Access Compliance Report

Public Rights-of-Way

(Curb Ramps)

Intersection ID: 45167	Main Street: ARAGORN_LN	Cross Street: STRIDER_DR	Location: W
ADA ID: 1AE3FEF8DD89	Ramp Type: PerpDiag	Initial Pass/Fail: Fail	Overall Compliance: No
Severity Score: 18.75			
Codes/Mitigation Info/Possible Solution		Field Measurements/Component Compliance

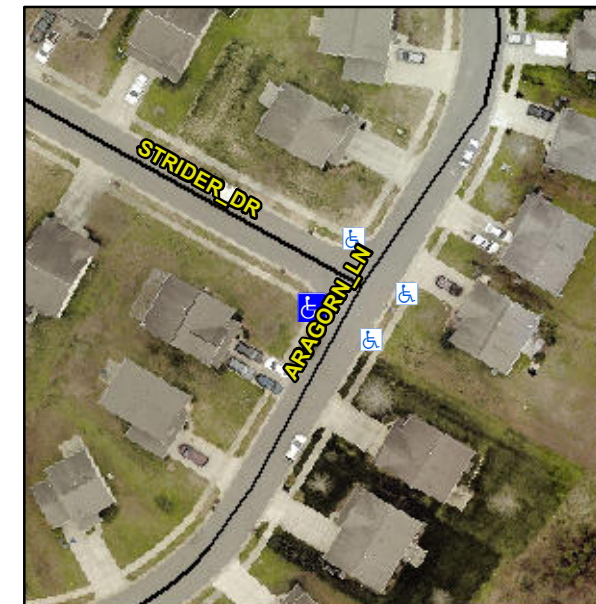
Remove & Replace Curb Ramp With Two New Directional Ramps or Equivalent.

R304.5.1, R304.5.3

Compliance	Description	Data	Compliance	Description	Data
N/A	Ramp Length (in)	45.0	Yes	Ramp Slope (%)	8.2
No	Ramp Width (in)	33.0	No	Ramp XSlope (%)	2.6
N/A	Flare Type LT	N/A	N/A	Flare Type RT	N/A
N/A	Flare Slope LT (%)	N/A	N/A	Flare Slope RT (%)	N/A
N/A	Flare Traversable LT?	N/A	N/A	Flare Traversable RT?	N/A
N/A	Landing Length (in)	N/A	N/A	DWS Provided?	N/A
N/A	Landing Width (in)	N/A	N/A	DWS Contrast?	N/A
N/A	Landing Slope (%)	N/A	N/A	DWS Length (in)	N/A
N/A	Landing X Slope (%)	N/A	N/A	DWS Full Width?	N/A
N/A	Landing Curb? (Y/N)	N/A	N/A	DWS Offset (in)	N/A
N/A	Shared Landing?	N/A			
N/A	Gutter Ponding?	N/A	N/A	Gutter Slope (%)	N/A
N/A	Gutter Lip Ht (in)	N/A	N/A	Gutter X Slope (%)	N/A
N/A	Painted X Walk1?	No	N/A	Painted X Walk2?	No
	X Walk 1 Direction	To SE		X Walk 2 Direction	To NE
N/A	X Walk 1 Width (in)	N/A	N/A	X Walk 2 Width (in)	N/A
	X Walk 1 Slope (%)	2.5		X Walk 2 Slope (%)	1.1
	X Walk 1 X Slope (%)	0.2		X Walk 2 X Slope (%)	2.5
